Aachua County Development Review Committee Staff Report

Project Number: DR24-000013

Final Development Plan and Floodplain Development Permit for Taylor Dock and Boathouse

SUBJECT: Taylor Dock and Boathouse

Figure 404.108.1

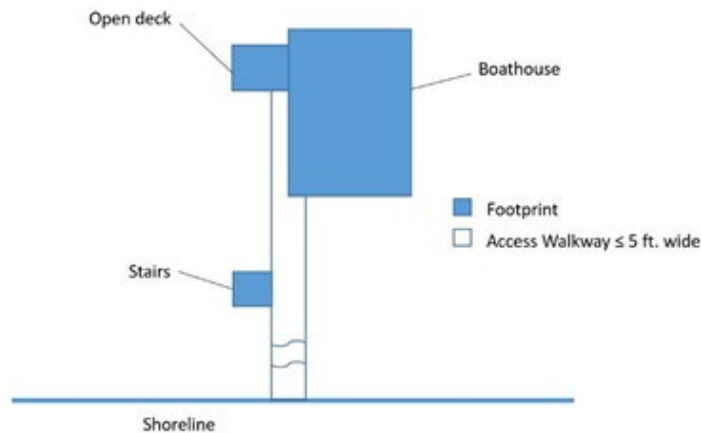
The structure is made up of a covered boathouse/boat lift area that is 16 feet wide by 29 feet long (464 square feet), an uncovered deck that is 13 feet wide by 17 feet long (221 square feet), and a covered jet ski lift area that is 14 feet wide by 12 feet long (168 square feet). The total size of the dock is 853 square feet.
